Staff Report for PLPR-2607-0002

Application Type: MU-C Planning Review

Location of Subject: 4088 Haines Road

The applicant is proposing a 1-story, 5,050 sq. ft. bank with drive-through canopy.

LANDSCAPE
PLAN

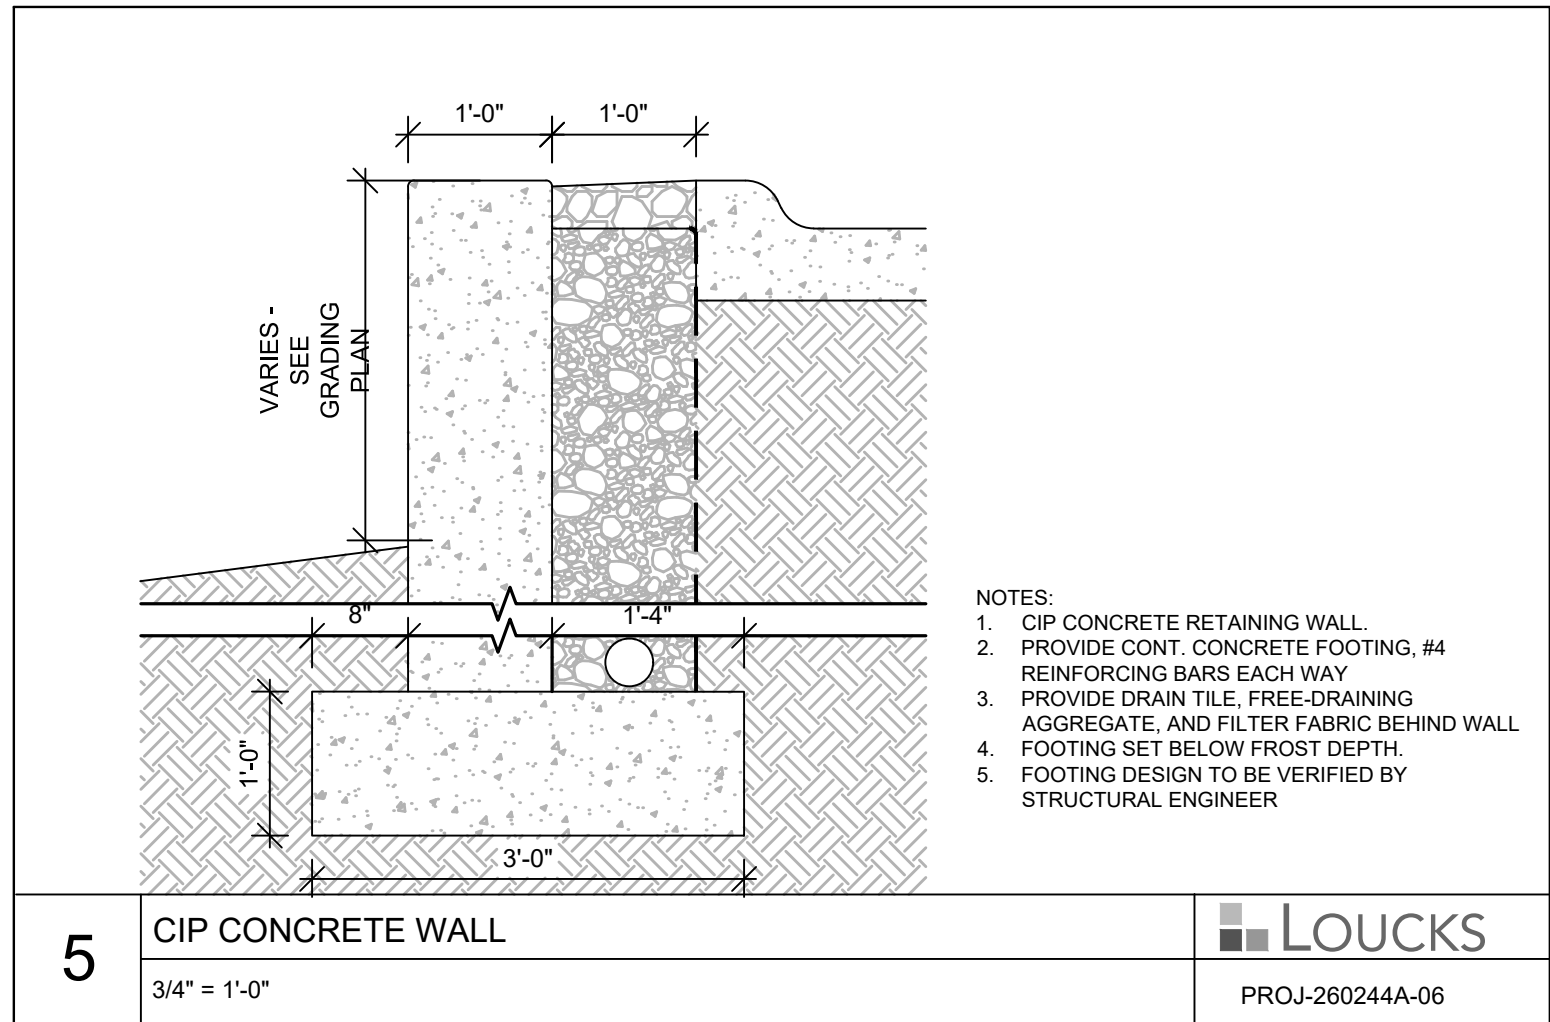
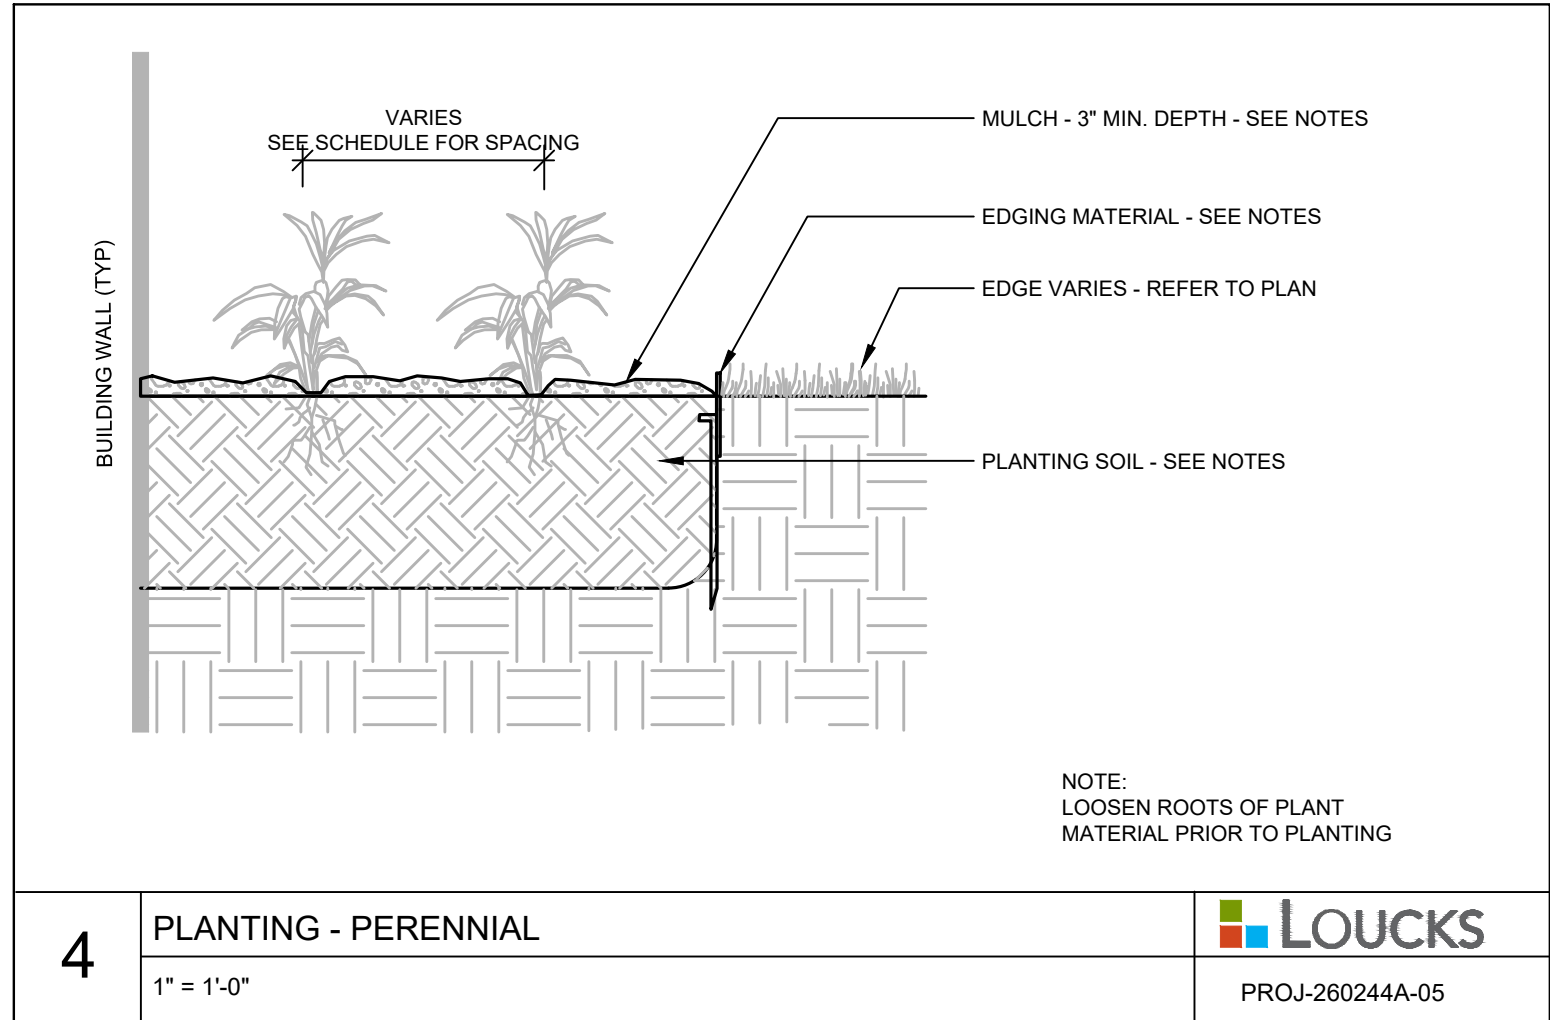
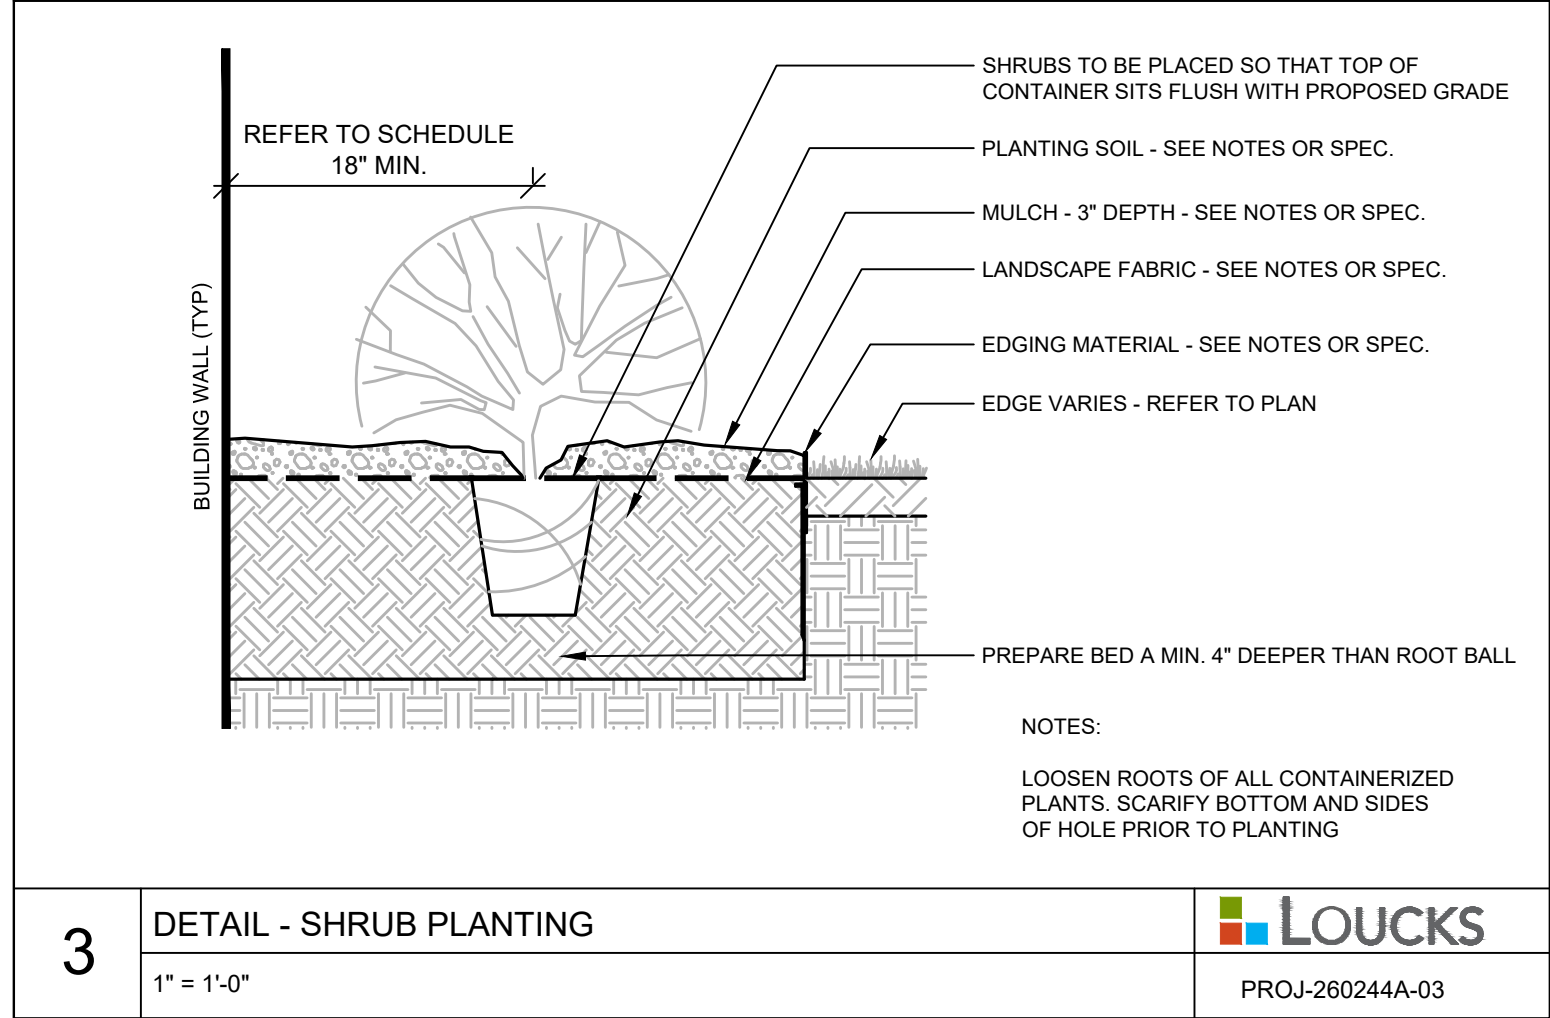
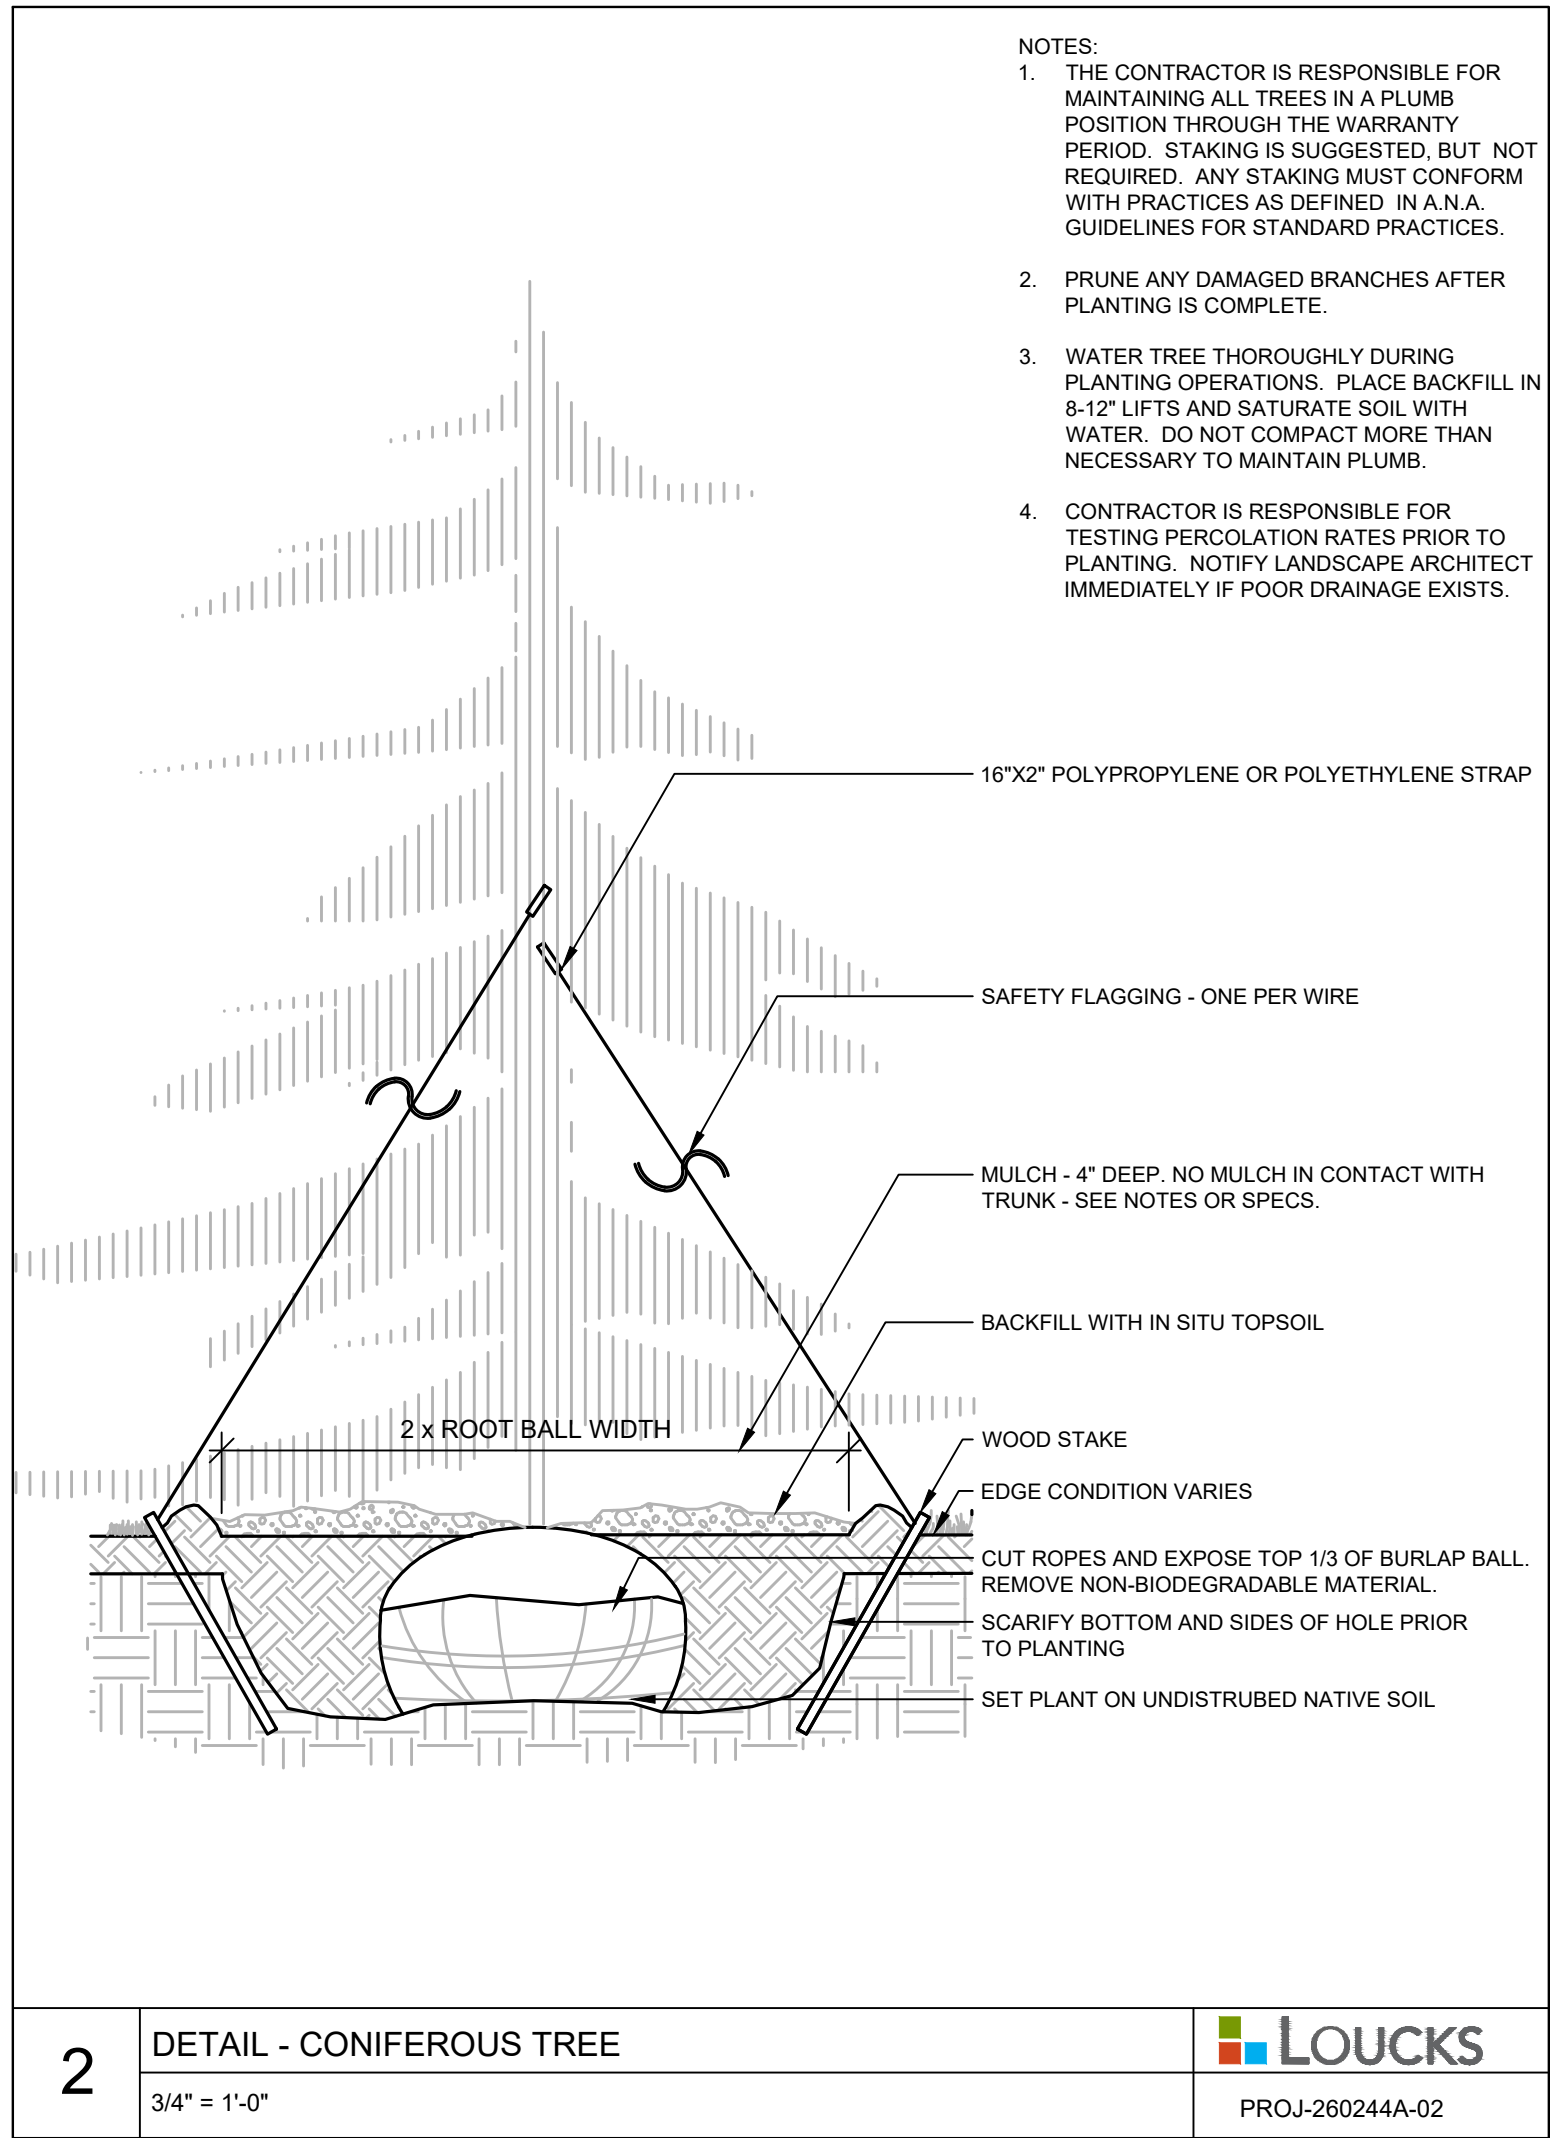
3. Section 50-22.3.E (Use Specific Standards, Bank) – The landscaping plan indicates there will be a dense urban screen between the drive-through and the adjacent residential property with a vegetative buffer as shown in the landscaping plan.
